# Access Compliance Report

## Public Rights-of-Way (Curb Ramps)

Intersection ID: 43078	Main Street: WESLEY_HEIGHTS_WY	Cross Street: WESTBROOK_DR	Location: S
ADA ID: DD17D2355936	Ramp Type: Para	Initial Pass/Fail: Fail	Overall Compliance: No
		Severity Score: 25

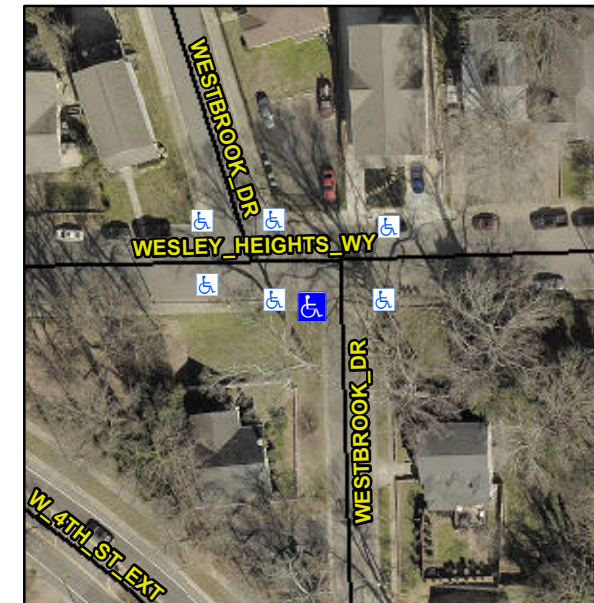
**RT RP < 5%**

**R304.3.2**

Compliance	Description	Data	Compliance	Description	Data
N/A	Ramp Length LT (in)	44.0	N/A	Ramp Length RT (in)	24.0
Yes	Ramp Width LT (in)	60.0	Yes	Ramp Width RT (in)	70.0
No	Ramp Slope LT (%)	12.8	Yes	Ramp Slope RT (%)	0.4
Yes	Ramp XSlope LT (%)	1.1	Yes	Ramp XSlope RT (%)	1.0
N/A	Landing Length (in)	N/A	N/A	DWS Provided?	N/A
N/A	Landing Width (in)	N/A	N/A	DWS Contrast?	N/A
N/A	Landing Slope (%)	N/A	N/A	DWS Length (in)	N/A
N/A	Landing X Slope (%)	N/A	N/A	DWS Full Width?	N/A
N/A	Landing Curb? (Y/N)	N/A	N/A	DWS Offset (in)	N/A
N/A	Shared Landing?	N/A			
N/A	Gutter Ponding?	N/A	N/A	Gutter Slope (%)	N/A
N/A	Gutter Lip Ht (in)	0.5	N/A	Gutter X Slope (%)	N/A
N/A	Painted X Walk1?	No	N/A	Painted X Walk2?	N/A
	X Walk 1 Direction	To E		X Walk 2 Direction	N/A
N/A	X Walk 1 Width (in)	N/A	N/A	X Walk 2 Width (in)	N/A
	X Walk 1 Slope (%)	7.1		X Walk 2 Slope (%)	N/A
	X Walk 1 X Slope (%)	1.5		X Walk 2 X Slope (%)	N/A
N/A	Ramp inside XWalk1?	N/A	N/A	Ramp inside XWalk2?	N/A

**Remove & Replace Entire Ramp.**
